Access Compliance Report Public Rights-of-Way (Curb Ramps)

Main Street: SMOKE_TREE_LN Cross Street: NEWPORT_AVE Location: S

ADA ID: RPAT211018095234 Ramp Type: Type 3 - Combination 1 Initial Pass/Fail: Fail Overall Compliance: No Severity Score: 2

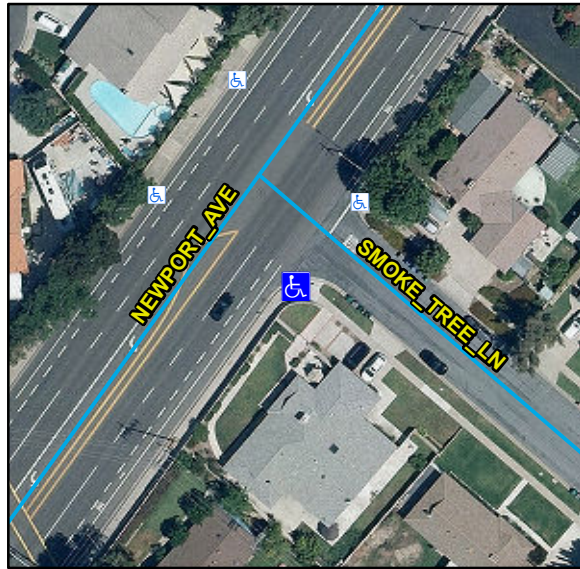
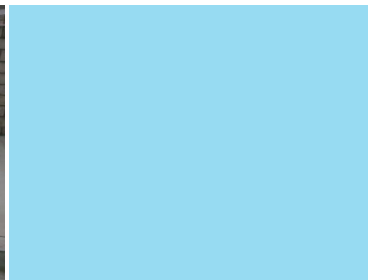
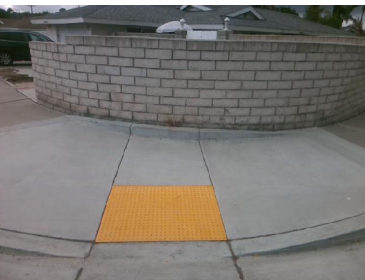
R304.2.2, R304.5.3, STD 1115

Compliance	Description	Data	Compliance	Description	Data
N/A	Ramp Length LT (in)	66	N/A	Ramp Length RT (in)	99
Yes	Ramp Width LT (in)	53	Yes	Ramp Width RT (in)	60
Yes	Ramp Run Slope LT (%)	7.6	Yes	Ramp Run Slope RT (%)	5.1
No	Ramp Cross Slope LT (%)	3	No	Ramp Cross Slope RT (%)	3.3
N/A	Ramp Length (in)	48	N/A	Flare Type LT	
Yes	Ramp Width (in)	48			N/A
Yes	Ramp Run Slope (%)	6.9	N/A	Flare Slope LT (%)	N/A
Yes	Ramp Cross Slope (%)	0.9	N/A	Flare Traversable LT	N/A
N/A	Landing Present	N/A	N/A	Flare Type RT	
N/A	Landing Length (in)	N/A			N/A
N/A	Landing Width (in)	N/A	N/A	Flare Slope RT (%)	N/A
N/A	Landing Run Slope (%)	N/A	N/A	Flare Traversable RT	N/A
N/A	Landing Cross Slope (%)	N/A	N/A	DWS Provided	N/A
N/A	Landing Movement Obstructed?	N/A	N/A	DWS Contrast	N/A
	Landing Movement Type	N/A	N/A	DWS Length (in)	N/A
N/A	Landing Shared	N/A	N/A	DWS Full Width	N/A
N/A	Clear Space	Yes		DWS Offset Type	N/A
N/A	Clear Space To Crosswalk (in)	N/A	N/A	DWS Offset Left (in)	N/A

Remove & Replace Curb Ramp With Two New Directional Ramps or Equivalent.
